Access Compliance Report Public Rights-of-Way (Curb Ramps)

Main Street: N/A		Cross Street: S_GILBERT_ST		Location:	SW
ADA ID: RPAT211119132534	Ramp Type: Type 4 - Parallel	Initial Pass/Fail: Fail	Overall Compliance: No	Severity Score:	45
Codes/Mitigation Info/Possible Solution			Field Measurements/Component Compliance

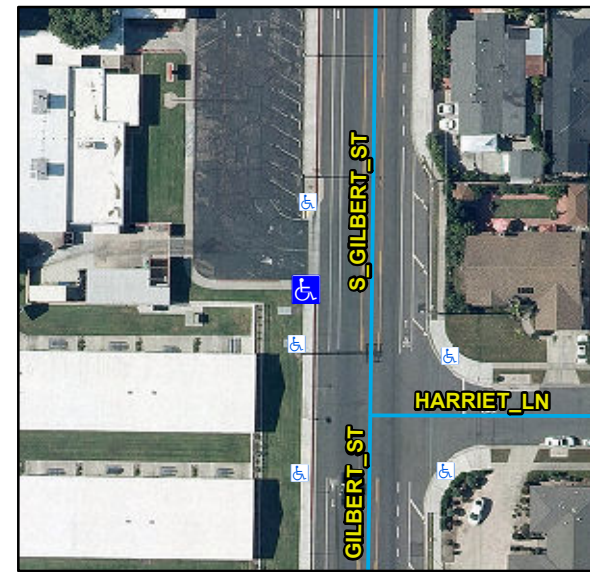
Compliance	Description	Data	Compliance	Description	Data
N/A	Ramp Length LT (in)	68	N/A	Ramp Length RT (in)	68
Yes	Ramp Width LT (in)	69	Yes	Ramp Width RT (in)	61
Yes	Ramp Run Slope LT (%)	8	No	Ramp Run Slope RT (%)	9.7
No	Ramp Cross Slope LT (%)	8.6	Yes	Ramp Cross Slope RT (%)	1.4
N/A	Landing Present	N/A	N/A	DWS Provided	N/A
N/A	Landing Length (in)	N/A	N/A	DWS Contrast	N/A
N/A	Landing Width (in)	N/A	N/A	DWS Length (in)	N/A
N/A	Landing Run Slope (%)	N/A	N/A	DWS Full Width	N/A
N/A	Landing Cross Slope (%)	N/A		DWS Offset Type	N/A
N/A	Landing Movement Obstructed?	N/A	N/A	DWS Offset Left (in)	N/A
	Landing Movement Type	N/A	N/A	DWS Offset Right (in)	N/A
N/A	Landing Shared	N/A			
N/A	Clear Space	N/A			
N/A	Clear Space To Crosswalk (in)	N/A			
N/A	Marked Crosswalk 1	No	N/A	Marked Crosswalk 2	N/A
	Crossing 1 Direction	N		Crossing 2 Direction	N/A
	Marked Crosswalk 1 Width (in)	N/A		Marked Crosswalk 2 Width (in)	N/A

N/A	Ramp Inside Crosswalk 1	N/A	N/A	Ramp Inside Crosswalk 2	N/A
	Crossing 1 Slope (%)	0.5		Crossing 2 Slope (%)	N/A
	Crossing 1 Cross Slope (%)	5.6		Crossing 2 Cross Slope (%)	N/A
N/A	Gutter Ponding	N/A	N/A	Curb Slope	6.5
Yes	Gutter Lip Height (in)	0		Road Run Slope (%)	N/A
N/A	Gutter Run Slope (%)	N/A		Road Cross Slope (%)	N/A
N/A	Gutter Cross Slope (%)	N/A	No	Perpendicular Joint Present	No
Yes	Overall Surface Condition	Acceptable			
	Cross Gutter Present?	No		Spandrel Present?	No
	Replace Cross Gutter?	N/A		Replace Spandrel?	N/A

Remove & Replace Entire Ramp.
